MARK	DATE	DESCRIPTIONS	BY	CH'D	CCO#
2	07/12/13	MISCELLANEOUS SCADA CHANGES	RR RSB	RG	305
1	05/13/13	MISCELLANEOUS SCADA CHANGES	RR RSB	RG	305
0	06/23/10	DEHUMIDIFIER SCADA INTERFACE	RR	RG FW	130

CONTRACT CHANGE ORDER NO. 305
SHEET 2 OF 23

DETAILS
TOWER AND SUSPENSION CABLE TOWER POWER AND LIGHTING
NN SCALE

DETAILS
SCADA REMOTE TERMINAL UNIT SYSTEM
RTU #10W ELEMENTARY AND CONNECTION DIAGRAM
NO SCALE

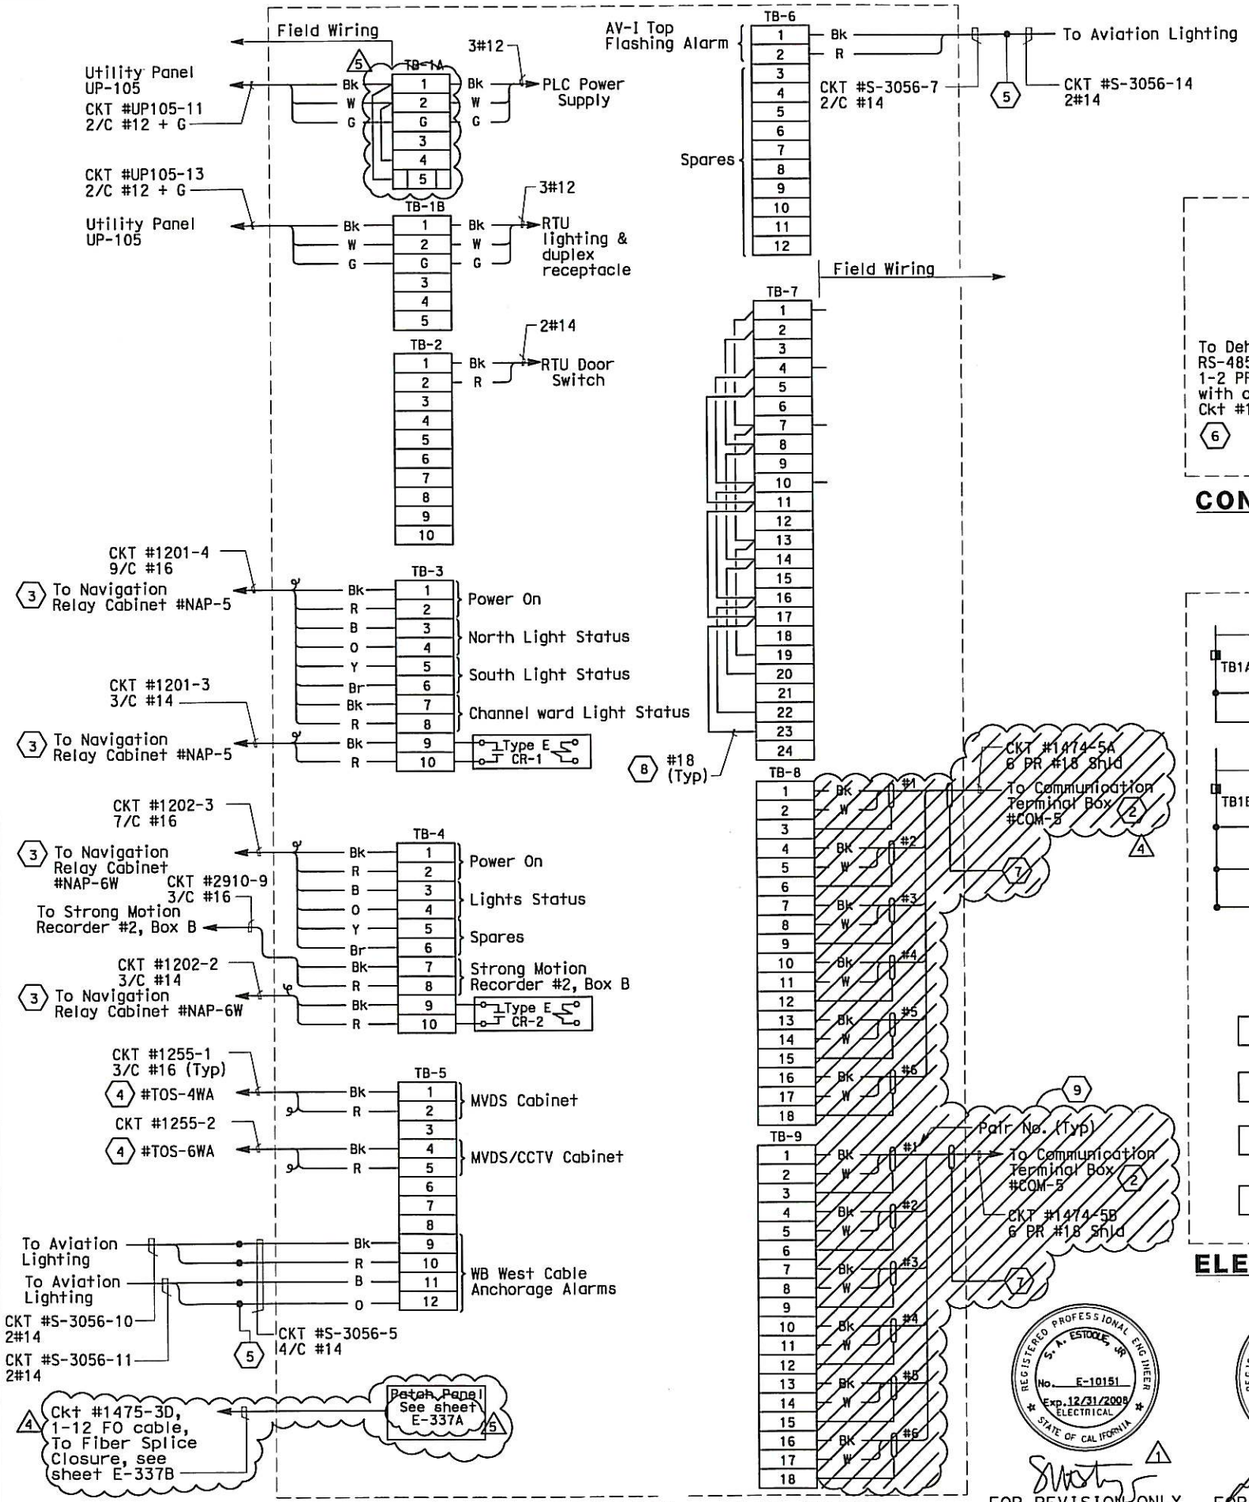
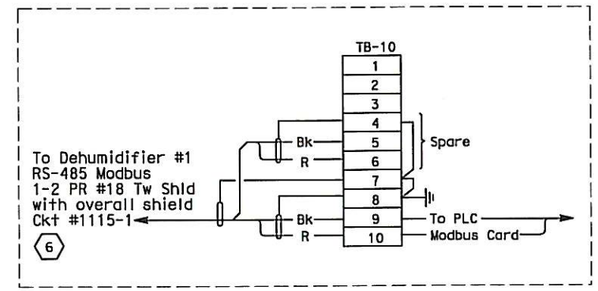
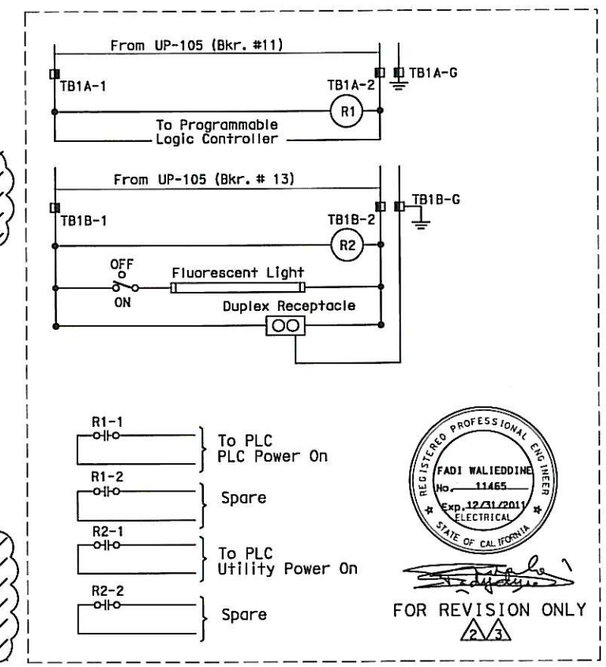
1. Deleted.
2. For connection diagram to scada system, see sheet E-324. (4)
3. For navigation system connection diagrams, see sheet E-303.
4. Connections to panel door switch. For remote alarm status to RTU.
5. Conductors spliced inside junction box PB-2A located inside the girder.
6. For connection diagram to dehumidification controller, see sheet E-79.
7. Field to tape cable overall shield wire. (4)
8. The Contractor shall install resistors, approximately equal to the impedance (Zo) of the twised pairs, at the extreme ends of the multidrop network. (4)
9. Abandon in place (hatched items) if installed.

MARK	DATE	DESCRIPTIONS	BY	CH'D	CCO#
5	07/12/13	MISCELLANEOUS SCADA CHANGES	RR RSB	RG	305
4	05/13/13	MISCELLANEOUS SCADA CHANGES	RR RSB	RG	305
3	02/01/10	DEHUMIDIFIER SCADA INTERFACE	RG	JE FW	130
2	08/03/09	ELECTRICAL WARNING SYSTEMS	RG	JE FW	61
1	03/04/08	BARRIER MODIFICATIONS	JS BM	RG SE	44

DETAILS
SCADA REMOTE TERMINAL UNIT SYSTEM
RTU #10W CONNECTION DIAGRAM
NO SCALE

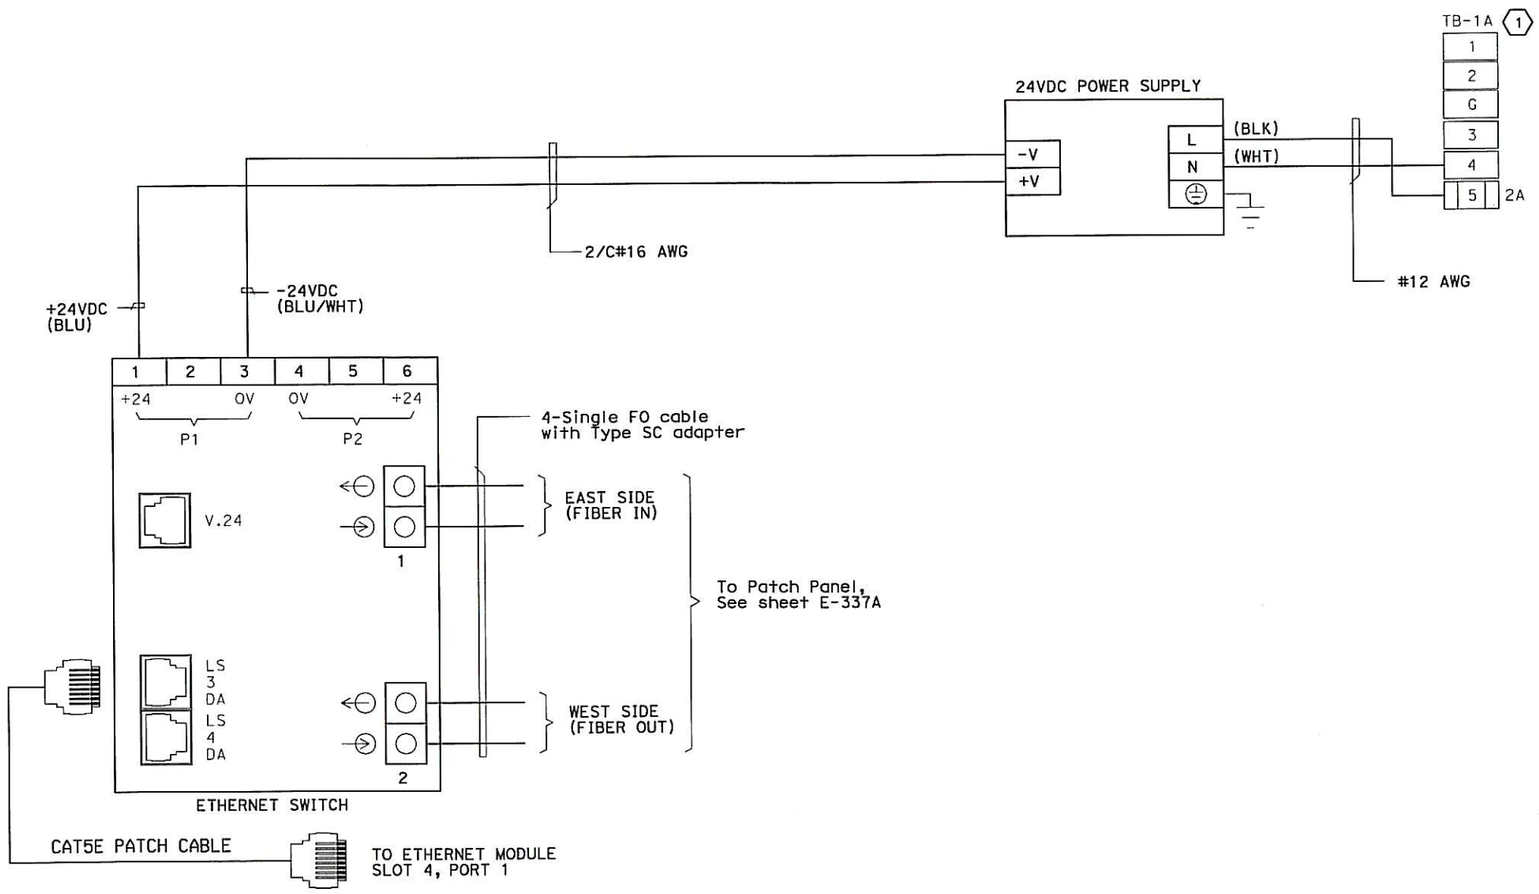
MARK	DATE	DESCRIPTIONS	BY	CH'D	CCO#
0	07/12/13	MISCELLANEOUS SCADA CHANGES	RR RSB	RG	305

DETAILS
SCADA REMOTE TERMINAL UNIT SYSTEM
RTU #10E ELEMENTARY AND CONNECTION DIAGRAM
NO SCALE

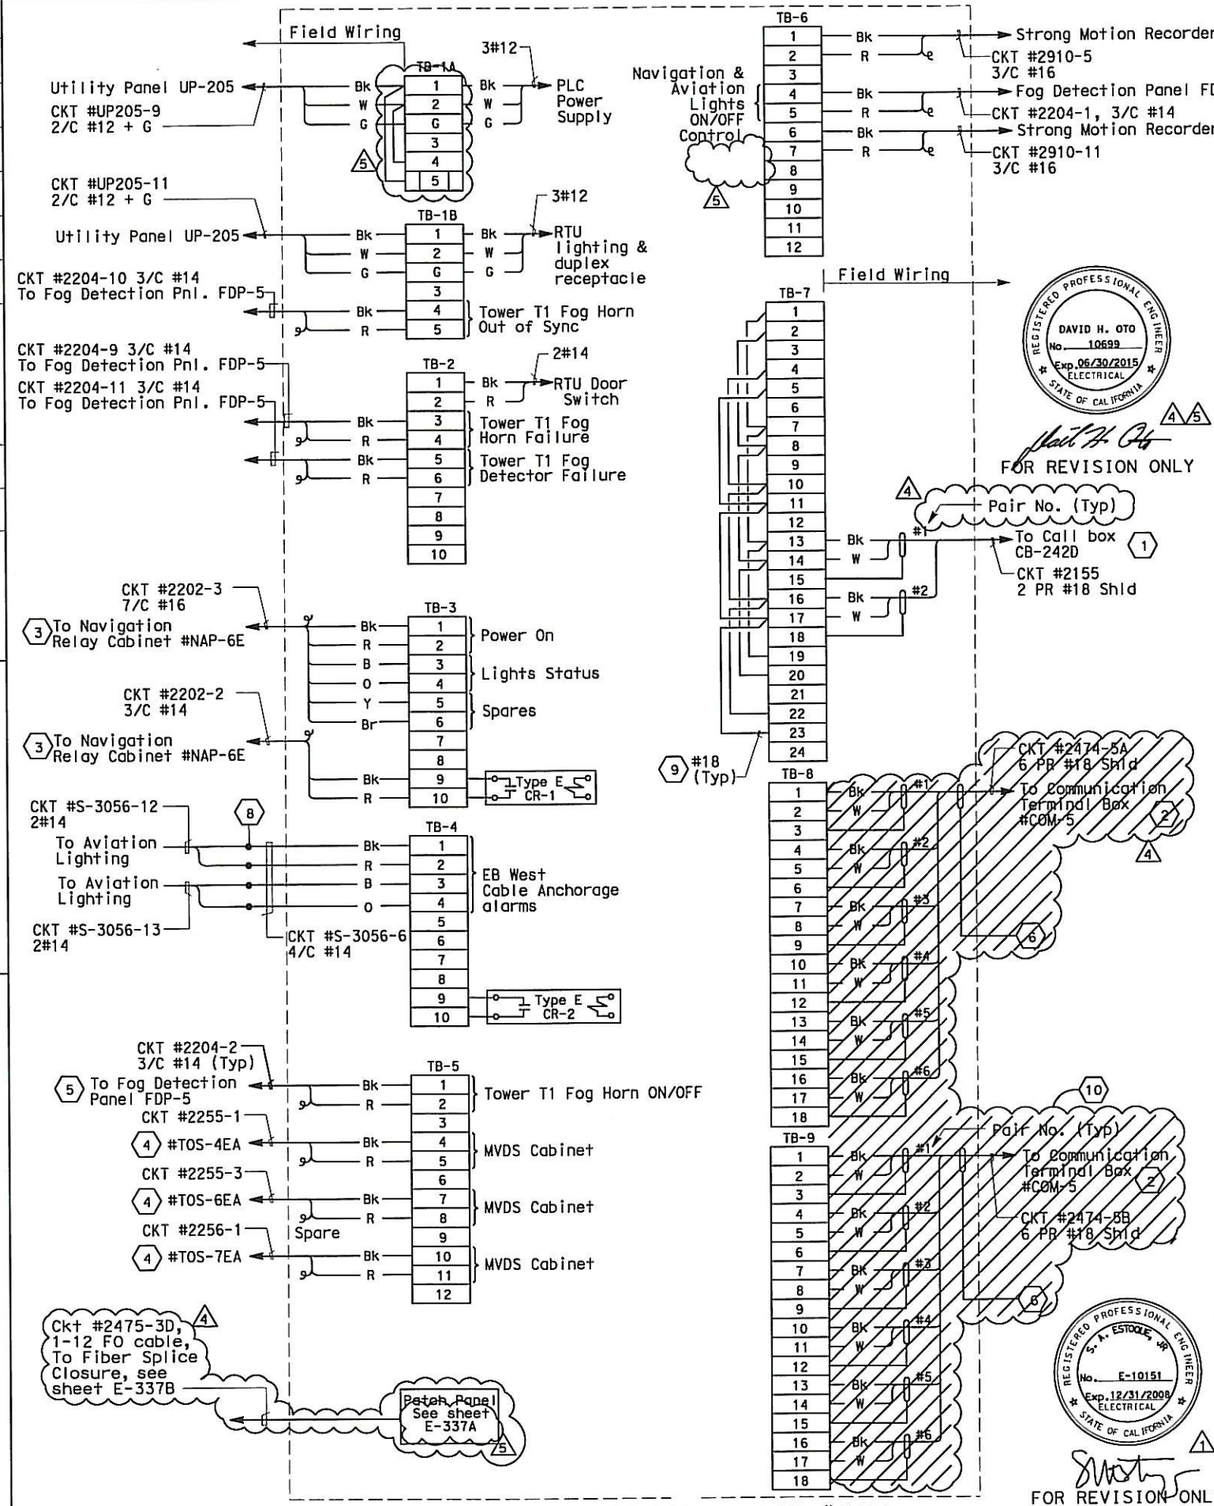
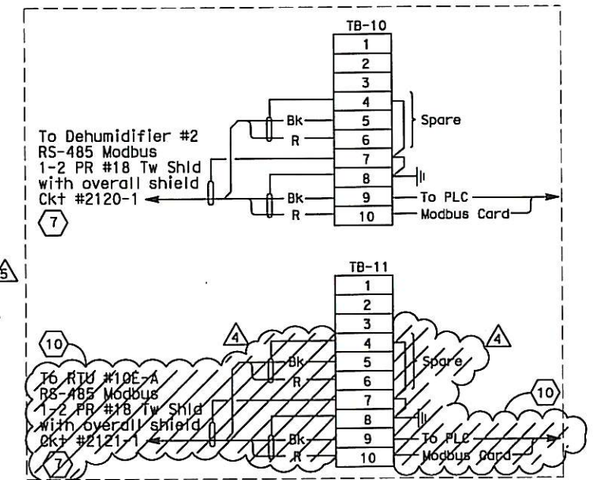
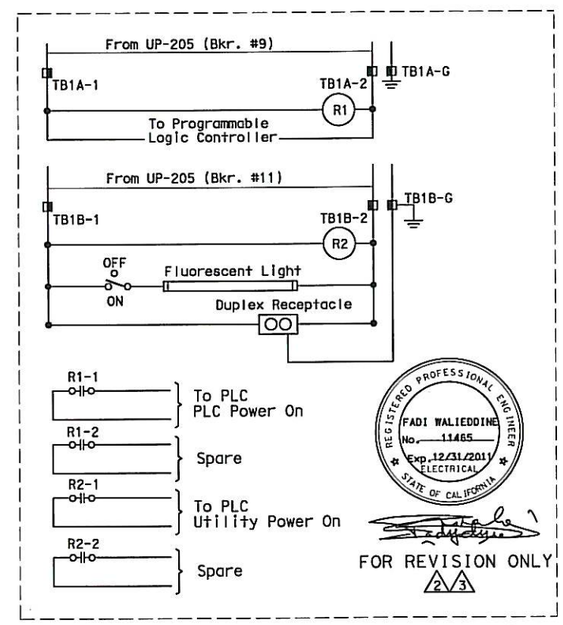
1. For Connection Diagram to Call Boxes, see sheet E-399.
2. For Connection Diagram to SCADA System, see sheet E-325. (4)
3. For Connection Diagram to Navigation System, see sheet E-303.
4. Connections to panel door switch. For remote alarm status to RTU.
5. For Connection Diagram to Fog Detection Panel, see sheet E-300.
6. Field to tape cable overall shield wire. (4)
7. For Connection Diagram to Dehumidification Controllers, see sheet E-79.
8. Conductors spliced inside junction box PB-2A located inside the girder.
9. The Contractor shall install resistors, approximately equal to the impedance (Zo) of the twisted pairs, at the extreme ends of the multidrop network. (4)
10. Abandon in place (hatched items) if installed.

MARK	DATE	DESCRIPTIONS	BY	CH'D	CCO#
5	07/12/13	MISCELLANEOUS SCADA CHANGES	RR RSB	RG	305
4	05/13/13	MISCELLANEOUS SCADA CHANGES	RR RSB	RG	305
3	02/01/10	DEHUMIDIFIER SCADA INTERFACE	RG	JE FW	130
2	08/03/09	ELECTRICAL WARNING SYSTEMS	RG	JE FW	61
1	03/04/08	BARRIER MODIFICATIONS	JS BM	RG SE	44

CONNECTION DIAGRAM - RTU #11W

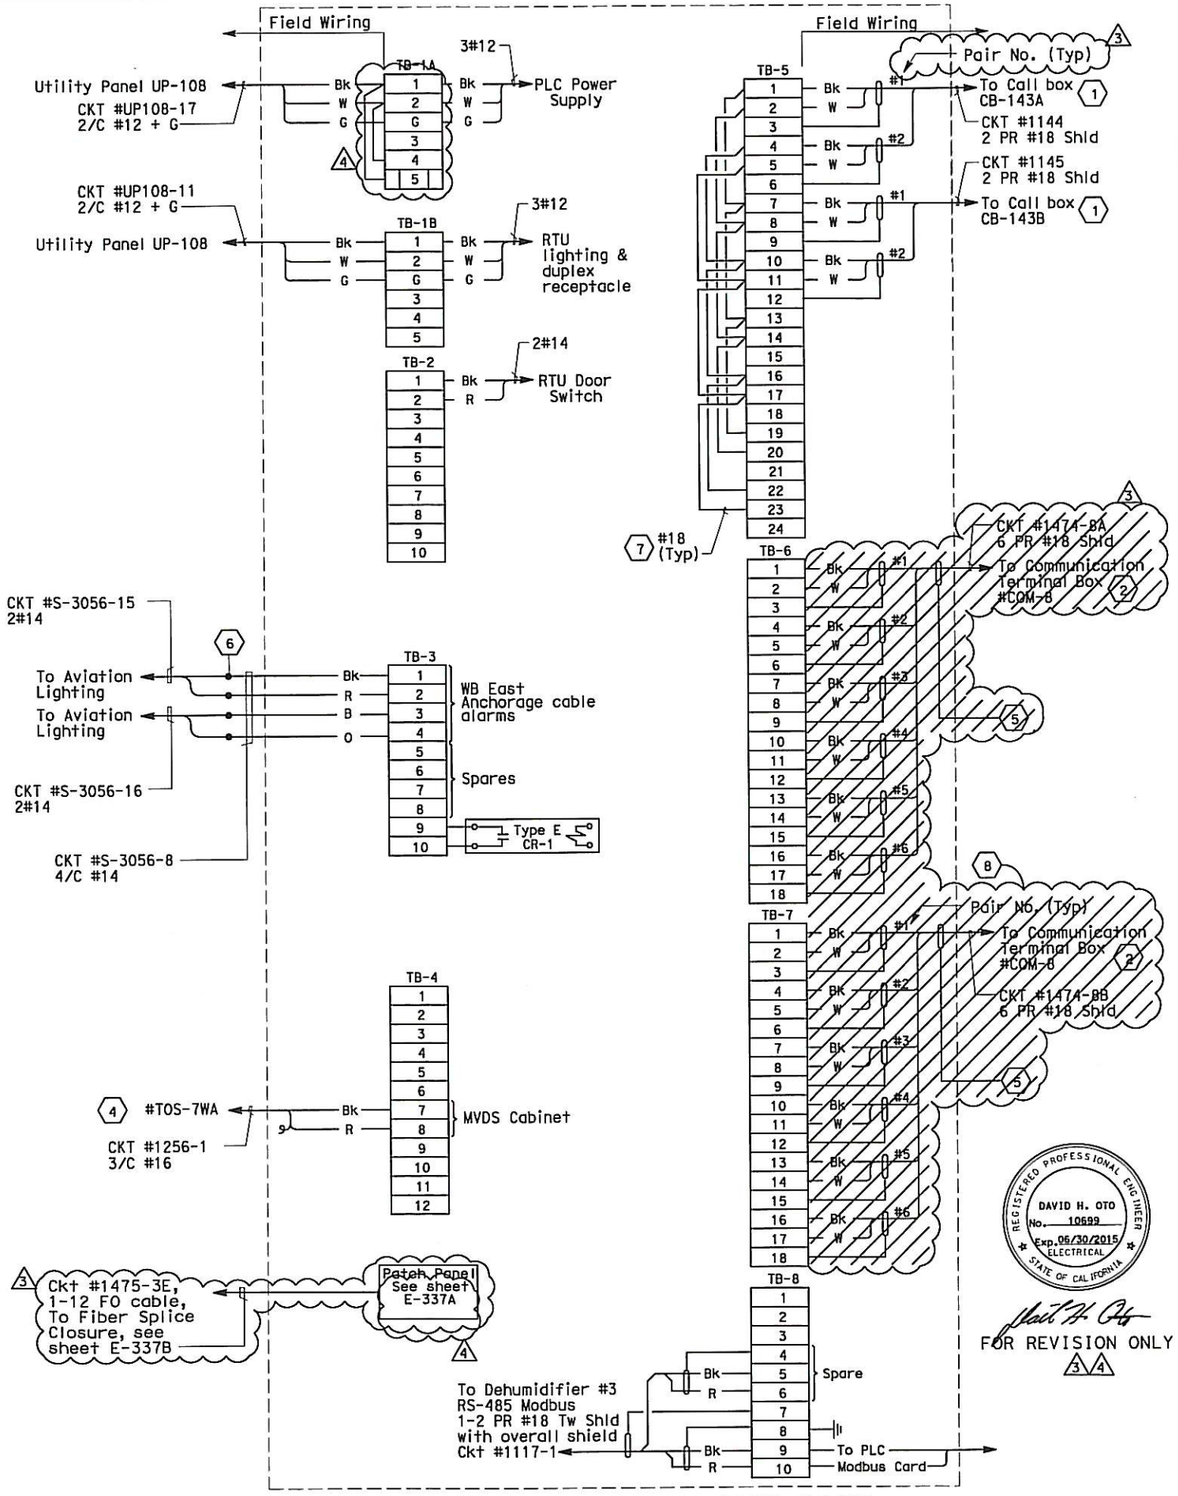
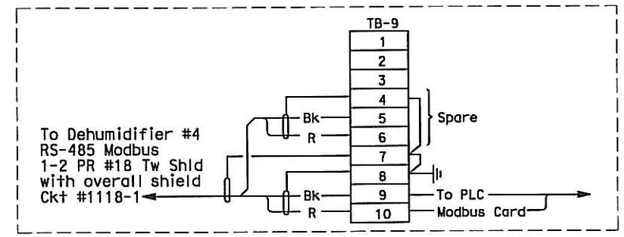
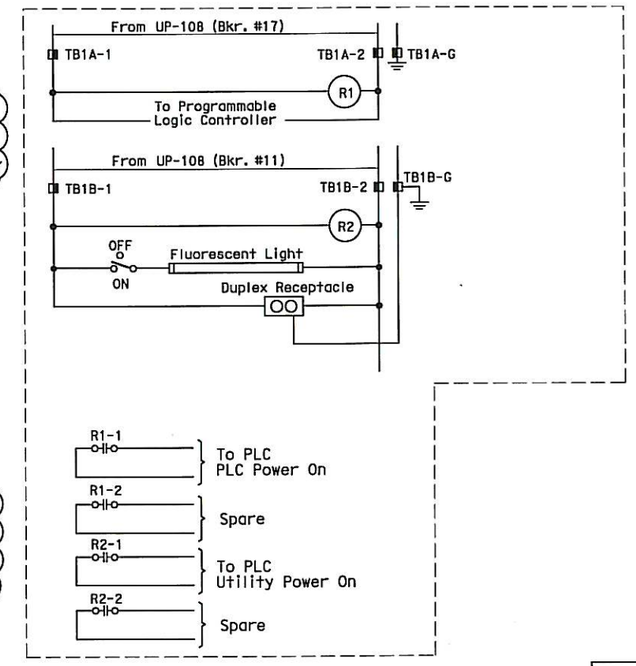
1. For connection diagram to call boxes, see sheet E-398.
2. For connection diagram to scada system, see table A, sheet E-325. (3)
3. For connection diagram to dehumification controllers, see sheets E-79.
4. Connections to panel door switch. For remote alarm status to RTU.
5. Field to tape cable overall shield wire. (3)
6. Conductors spliced inside junction box PB-2A located inside the girder.
7. The Contractor shall install resistors, approximately equal to the impedance (Zo) of the twised pairs, at the extreme ends of the multidrop network.
8. Abandon in place (hatched items) if installed. (3)

MARK	DATE	DESCRIPTIONS	BY	CH'D	CCO#
4	07/12/13	MISCELLANEOUS SCADA CHANGES	RR RSB	RG	305
3	05/13/13	MISCELLANEOUS SCADA CHANGES	RR RSB	RG	305
2	02/01/10	DEHUMIDIFIER SCADA INTERFACE	RG	JE FW	130
1	03/04/08	BARRIER MODIFICATIONS	JS BM	RG SE	44
